Moisture Assessment Report

2629 Westgate Street, Unit A

Summary Page

Photo5.1

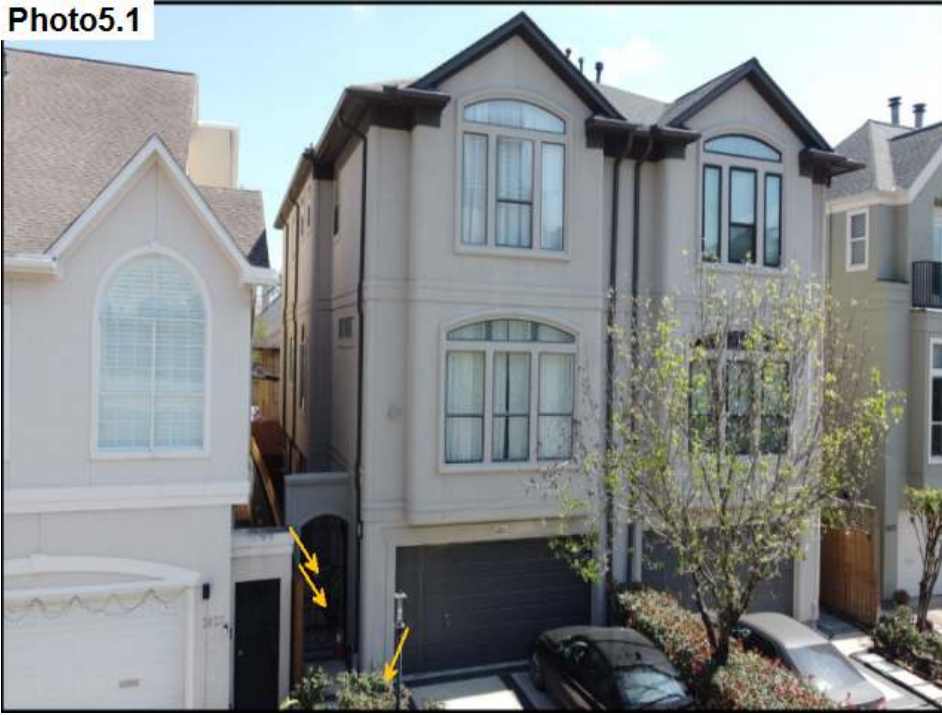
Grid Location	Item Description	Moisture Readings	Substrate Condition	Observations
Orange Arrows	Sprinklers			Sprinklers have been noted on this home. The inspector suggests to always redirect sprinkler heads away from the system and windows as needed in an effort to prevent moisture intrusion. Please refer to photos #5.2, #5.3, #5.4, #5.5 and #5.6 for more detail.

Sprinklers have been redirected.

Photo6.1

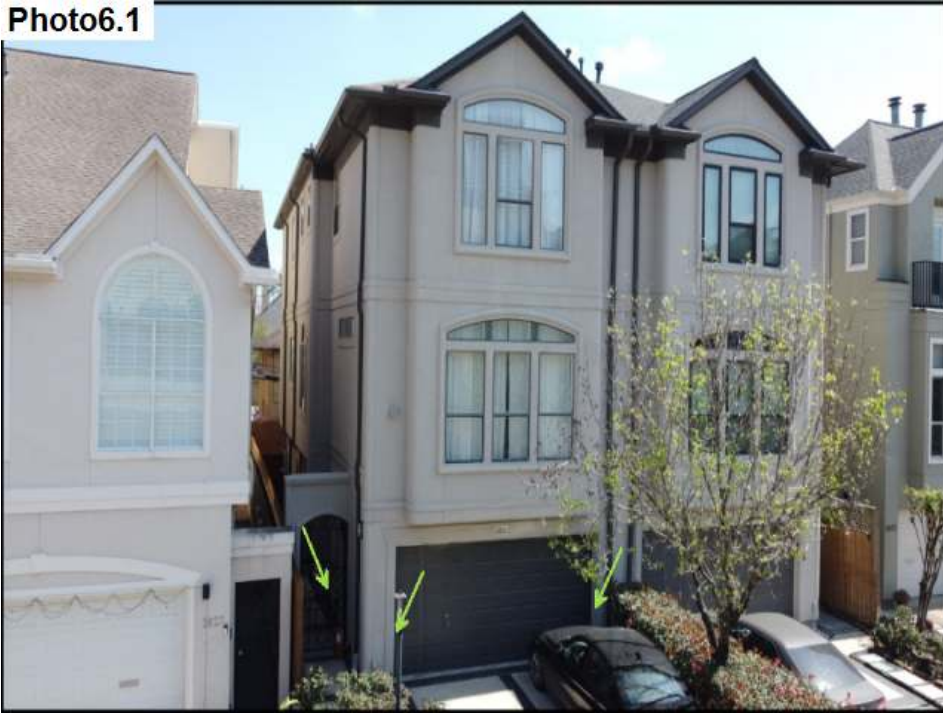
Grid Location	Item Description	Moisture Readings	Substrate Condition	Observations
Green Arrows	Doors			The door trim and miter sealants are aged, separated or missing at these locations. The inspector suggests to have a qualified waterproofing contractor seal these areas with a low modulus sealant in an effort to prevent moisture intrusion. These types of sealants are of high quality and compatible with stucco and other termination points. Please refer to photos #6.2, #6.3, #6.4, #6.5 and #6.6 for more detail.

All noted areas have been sealed/caulked.

Photo7.1

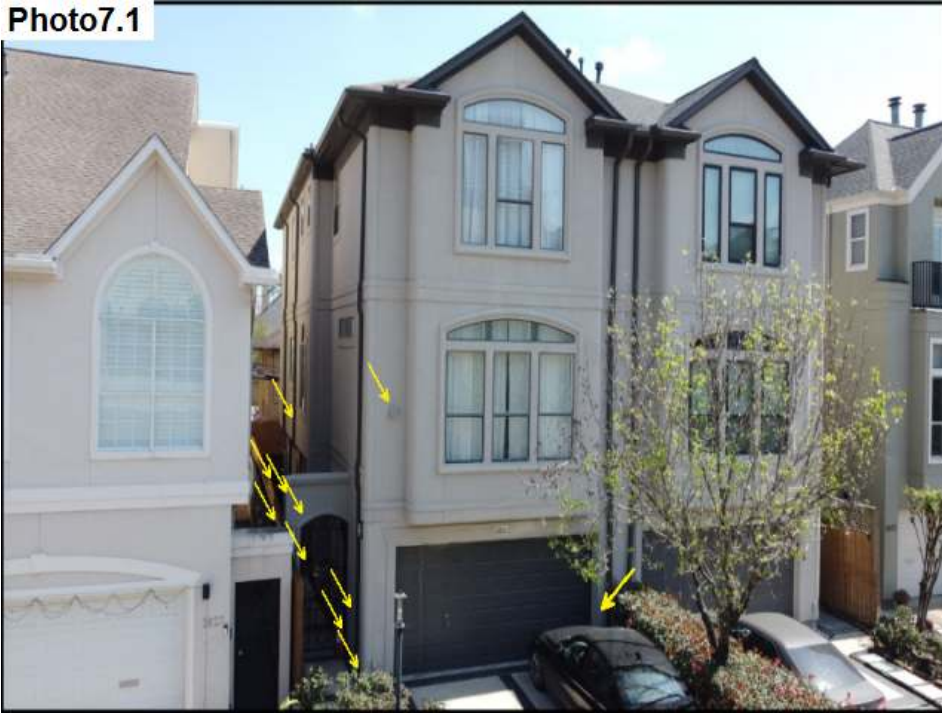
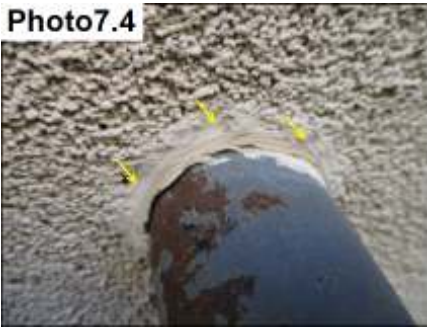
Grid Location	Item Description	Moisture Readings	Substrate Condition	Observations
Yellow Arrows	Penetrations			The penetration sealants are aged, separated or missing in these locations. The inspector suggests to have a qualified waterproofing contractor seal these areas with a low modulus sealant in an effort to prevent moisture intrusion. These types of sealants are of high quality and compatible with stucco and other termination points. Please refer to photos #7.2, #7.3, #7.4, #7.5 and #7.6 for more detail.

All noted areas have been sealed/caulked.

Photo8.4

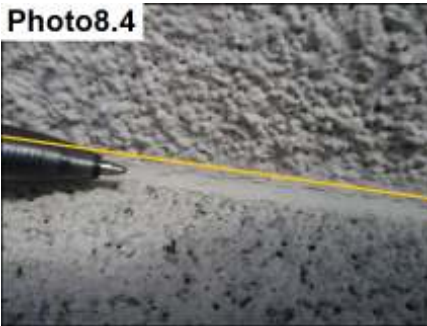
Grid Location	Item Description	Moisture Readings	Substrate Condition	Observations
Orange Lines	Accent & Stucco Termination			Accent terminations/stucco termination sealants are aged or separated at these locations. The inspector suggests to have a qualified waterproofing contractor further assess and seal these areas with a low modulus sealant in an effort to prevent moisture intrusion. These types of sealants are of high quality and compatible with stucco and other termination points. Please refer to photos #8.2, #8.3, #8.4, #8.5 and #8.6 for more detail.

All accent and stucco termination areas have been sealed.

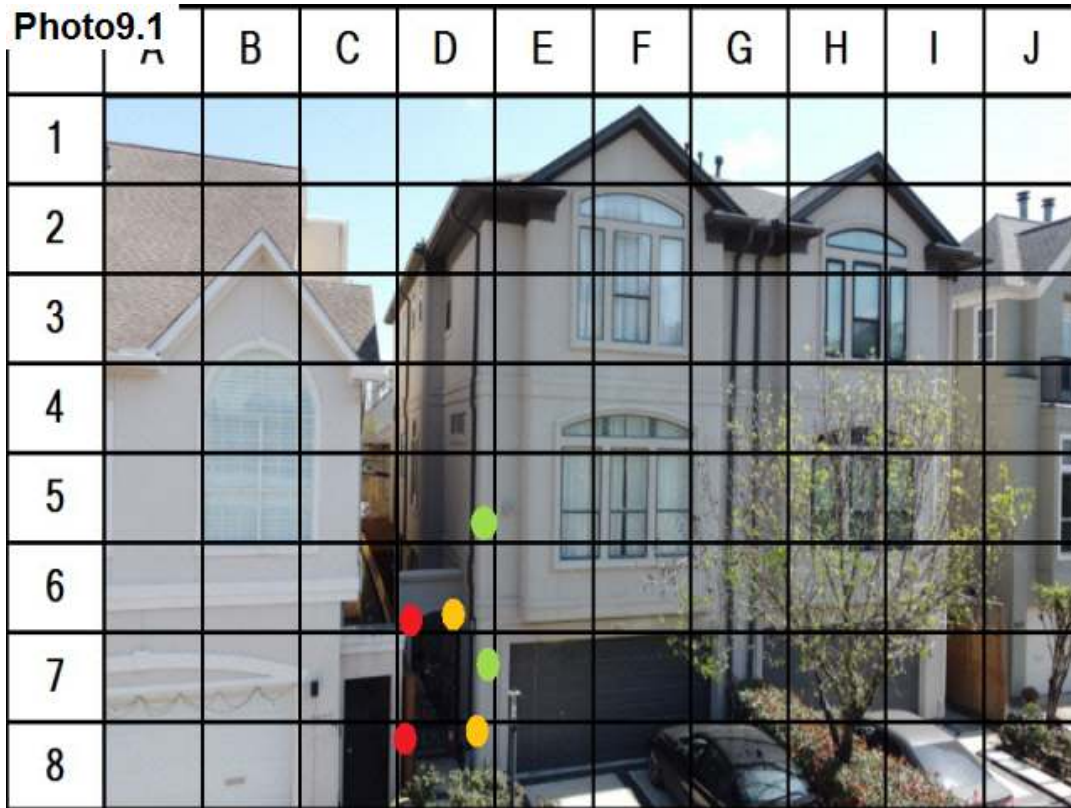
Grid Location	Item Description	Moisture Readings	Substrate Condition	Observations
D8 Red	Below Flat Accent		None	A moisture probe was taken at the left wall below the entryway flat accent. No substrate was noted at this time, modify as needed.
D8 Orange	Below Flat Accent	24%	Semi-Firm	A moisture probe was taken at the right wall below the entryway flat accent. An elevated moisture reading was noted with a semi-firm substrate.
D6 Red	Below Flat Accent		None	A moisture probe was taken below the bottom wall entryway flat accent. No substrate was noted at this time, modify as needed.
D6 Orange	Below Flat Accent		None	A moisture probe was taken at the bottom wall below the entryway flat accent. No substrate was noted at this time, modify as needed.
D7	Corner Wall	14%	Firm	A moisture probe was made at corner wall. The substrate was firm with no damage noted at this time.
D7	Corner Wall	13%	Firm	A moisture probe was made at corner wall. The substrate was firm with no damage noted at this time.

A metal cap was placed on the top of the entry way arch.

Photo10.1

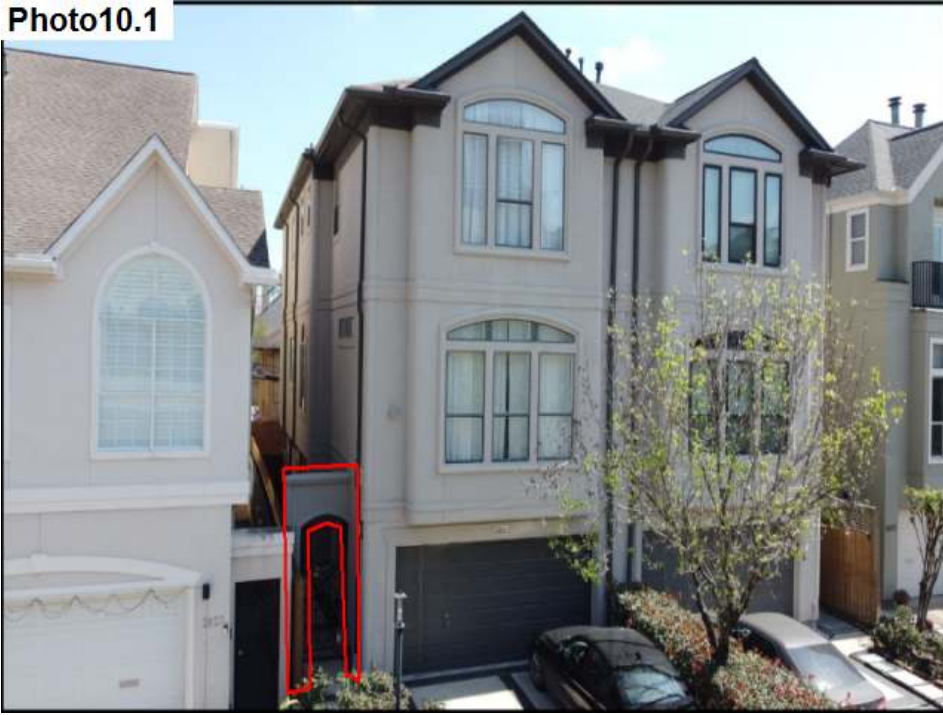
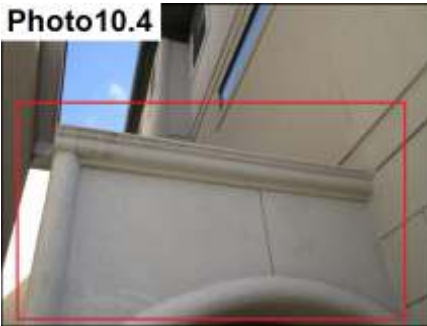
Grid Location	Item Description	Moisture Readings	Substrate Condition	Observations
Red Box	Damage			The entryway accent wall is missing a metal cap with sizable cracks at the wall of the structure allowing excess moisture into the system. Confirmed substrate and potential frame damage is noted at this location. The inspector recommends having a qualified waterproofing contractor further assess the extent of damage, repair as needed and install a proper relief and metal cap in an effort to prevent moisture intrusion. Please refer to photos #10.2, #10.3, #10.4, #10.5, 10.6, #11.1, #11.2, #11.3 and #11.4 for more detail.

A metal cap was placed on the top of the entry flat accent area. All cracks were caulked/sealed.

Photo11.4

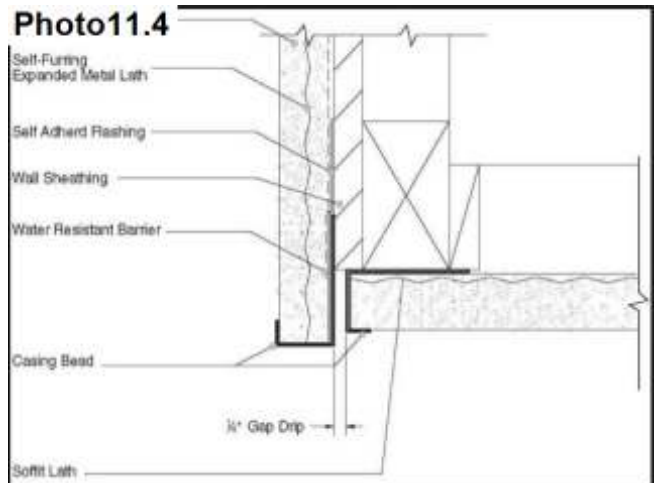
Damaged Entryway / Assess And Repair

Damaged Entryway / Assess And Repair

Damaged Entryway / Assess And Repair

[The entry area has been waterproofed.](#)

Photo12.1

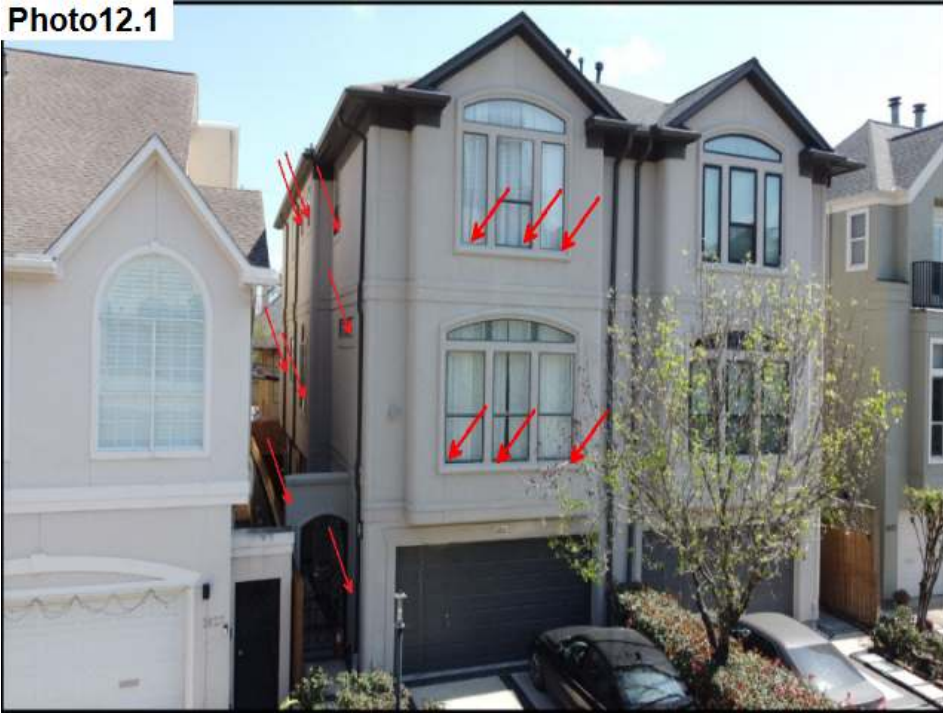
Grid Location	Item Description	Moisture Readings	Substrate Condition	Observations
Red Arrows	Windows			The window sealants are aged or separated. The inspector suggests to have a qualified waterproofing contractor further assess and seal these areas with a low modulus sealant in an effort to prevent moisture intrusion. These types of sealants are of high quality and compatible with stucco and other termination points. Please refer to photos #12.2, #12.3 #12.4, #12.5, #12.6, #13.1, #13.2, #13.3 and #13.4 for more detail.

All noted areas have been sealed/caulked.

Photo13.4

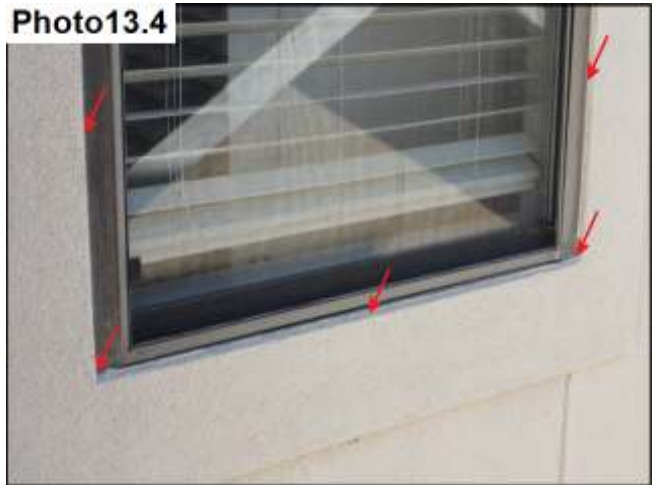
Window Sealants / Seal

All noted areas have been sealed/caulked.

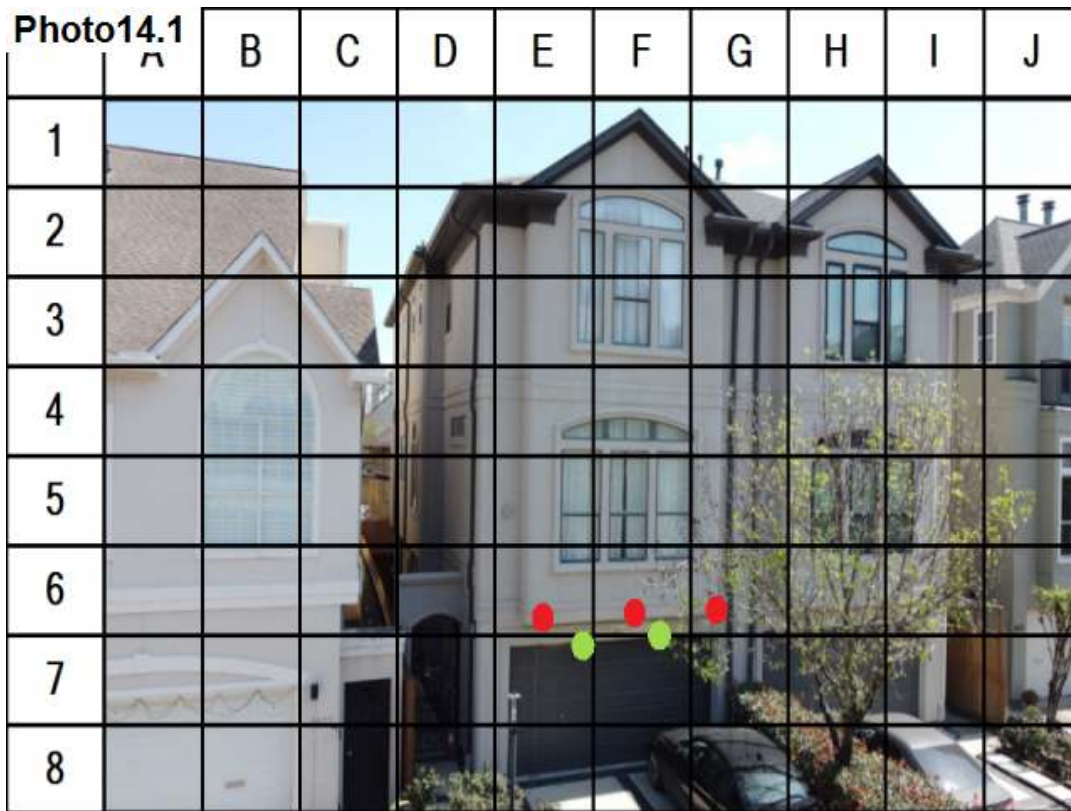
Grid Location	Item Description	Moisture Readings	Substrate Condition	Observations
E7	Garage Header	12%	Firm	A moisture probe was taken at the garage header below the bumpout wall. The substrate was firm with no damage noted at this time.
F7	Garage Header	12%	Firm	A moisture probe was taken at the garage header below the bumpout wall. The substrate was firm with no damage noted at this time.
E6	Bottom Bumpout Wall		None	A moisture probe was taken at the bottom bumpout wall below the bank of windows. No substrate was noted at this time, modify as needed.
F6	Bottom Bumpout Wall		None	A moisture probe was taken at the bottom bumpout wall below the bank of windows. No substrate was noted at this time, modify as needed.
G6	Bottom Bumpout Wall	29%	Semi-Firm	A moisture probe was taken at the bottom bumpout wall below the bank of windows. An elevated moisture reading was noted with a semi-firm substrate.

The bottom area of the bump out was removed, the damaged substrate was replaced. A relief has been added.

Photo15.1

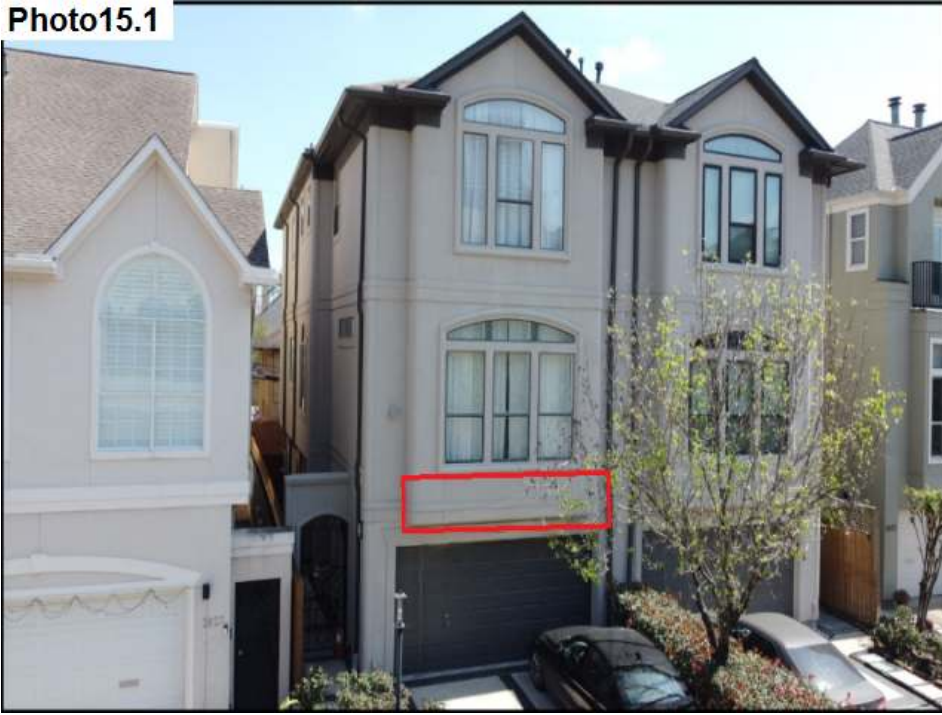
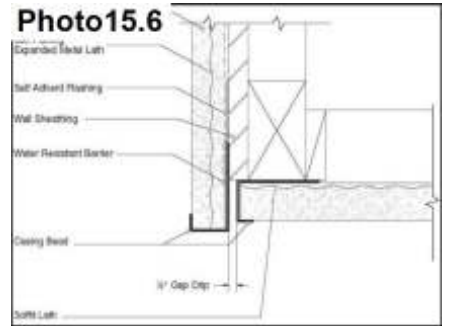
Grid Location	Item Description	Moisture Readings	Substrate Condition	Observations
Red Box	Damage			Confirmed substrate and potential frame damage is noted at the bottom of the bumpout wall below the bank of windows. The inspector recommends having a qualified waterproofing contractor further assess the extent of damage, repair as needed and install a proper relief in an effort to prevent moisture intrusion. Please refer to photos #15.2, #15.3, #15.4, #15.5 and #15.6 for more detail.

All damaged areas were replaced and a relief was added.

Photo17.1

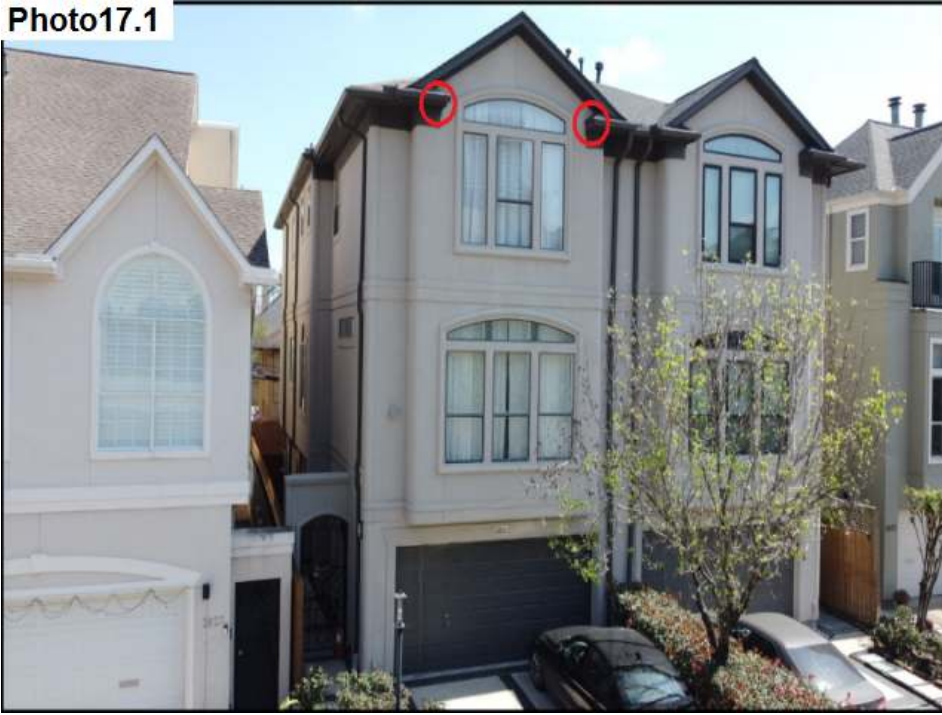
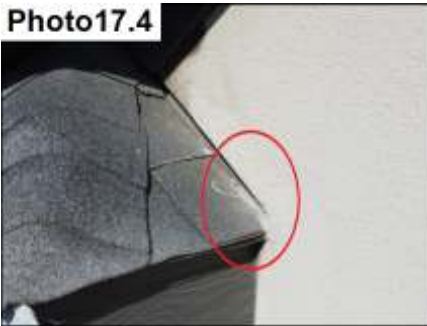
Grid Location	Item Description	Moisture Readings	Substrate Condition	Observations
Red Circles	Roof Termination			The roof and stucco termination is aged or separated at these locations. The inspector suggests to have a qualified waterproofing contractor further assess and seal these areas with a low modulus sealant in an effort to prevent moisture intrusion. These types of sealants are of high quality and compatible with stucco and other termination points. Please refer to photos #17.2, #17.3, #17.4, #17.5 and #17.6 for more detail.

The roof termination areas were caulked/waterproofed.

Photo18.1

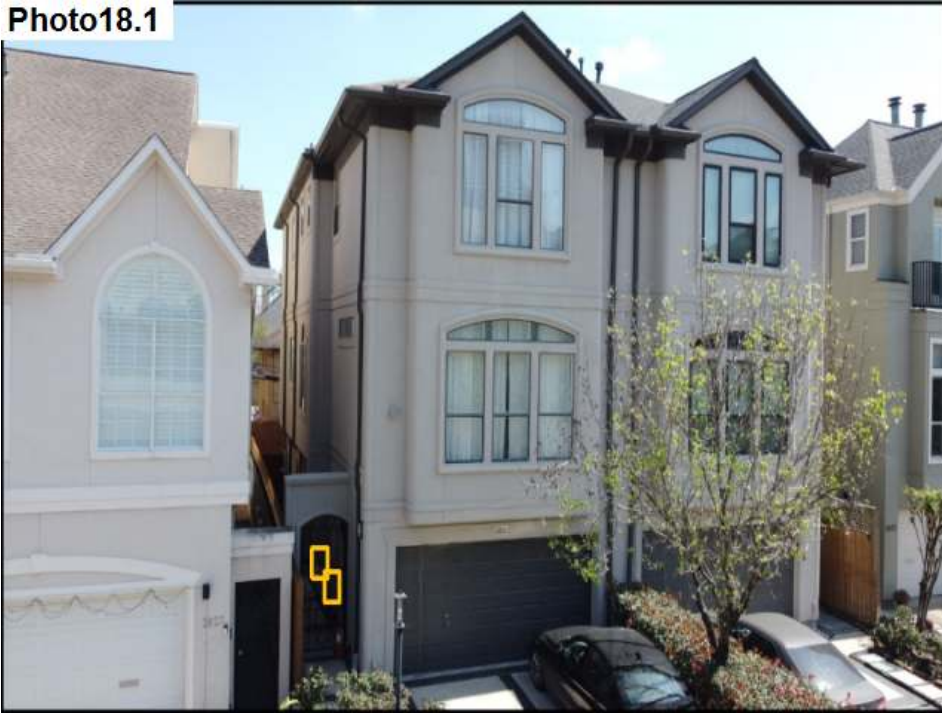
Grid Location	Item Description	Moisture Readings	Substrate Condition	Observations
Orange Boxes	Wood Rot			The door trim at this area has wood rot. The inspector suggests to have a qualified contractor further assess and repair this area as needed in an effort to prevent moisture intrusion. All wood rot was not necessarily identified in this report. Please refer to photos #18.2, #18.3, #18.4, #18.5 and #18.6 for more detail.

All rotted wood was replaced and painted.
